Intersection ID: 29768	Main Street: KNIGHT_CASTLE_DR	Cross Street: WILD_AZALEA_LN	Location:	NW
ADA ID: CBE704C23A9C	Ramp Type: PerpDiag	Initial Pass/Fail: Fail	Overall Compliance: No	Severity Score: 21.25

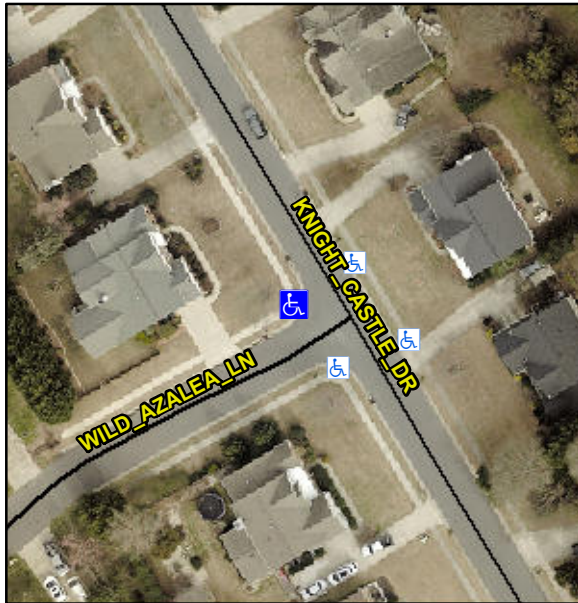
Not Found, R304.5.1, R304.5.3

Compliance	Description	Data	Compliance	Description	Data
N/A	Ramp Length (in)	94.0	Yes	Ramp Slope (%)	5.8
No	Ramp Width (in)	36.0	No	Ramp XSlope (%)	5.6
N/A	Flare Type LT	N/A	N/A	Flare Type RT	N/A
N/A	Flare Slope LT (%)	N/A	N/A	Flare Slope RT (%)	N/A
N/A	Flare Traversable LT?	N/A	N/A	Flare Traversable RT?	N/A
N/A	Landing Length (in)	N/A	N/A	DWS Provided?	N/A
N/A	Landing Width (in)	N/A	N/A	DWS Contrast?	N/A
N/A	Landing Slope (%)	N/A	N/A	DWS Length (in)	N/A
N/A	Landing X Slope (%)	N/A	N/A	DWS Full Width?	N/A
N/A	Landing Curb? (Y/N)	N/A	N/A	DWS Offset (in)	N/A
N/A	Shared Landing?	N/A			
N/A	Gutter Ponding?	N/A	N/A	Gutter Slope (%)	N/A
N/A	Gutter Lip Ht (in)	N/A	N/A	Gutter X Slope (%)	N/A
N/A	Painted X Walk1?	No	N/A	Painted X Walk2?	No
	X Walk 1 Direction	To SE		X Walk 2 Direction	To NE
N/A	X Walk 1 Width (in)	N/A	N/A	X Walk 2 Width (in)	N/A
	X Walk 1 Slope (%)	0.7		X Walk 2 Slope (%)	1.7
	X Walk 1 X Slope (%)	0.8		X Walk 2 X Slope (%)	1.1

Remove & Replace Curb Ramp With Two New Directional Ramps or Equivalent.
